REMARKS

The present amendment is in response to the Office action dated January 3, 2007, where the Examiner has rejected claims 1-24 and 26-28, and objected to claim 25. By the present amendment, claims 1, 7, 10 and 28 have been amended. Accordingly, claims 1-28 remain in the present application. Allowance of remaining claims 1-28, in view of the amendments and the following remarks, is respectfully requested.

Fig. 2A

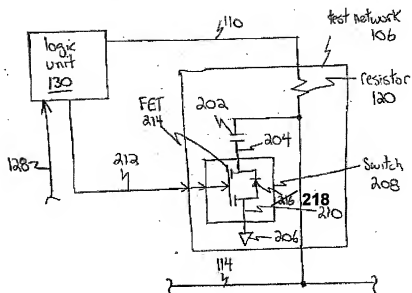
The drawings have been amended to correct typographical errors and to conform with the specification. Specifically, in Figure 2A, the diode "216" has been corrected as --218--. This change is made because reference number "216" is already used by resistor "216".

Fig. 2B

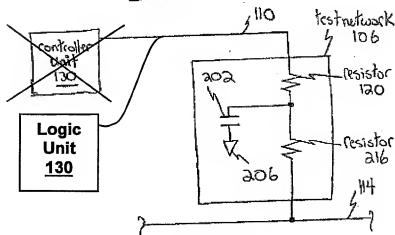
Also, in Figure 2B, "Controller Unit 130" has been corrected as --Logic Unit 130-- to conform with the specification (see, page 10, line 12). No new matter has been added.
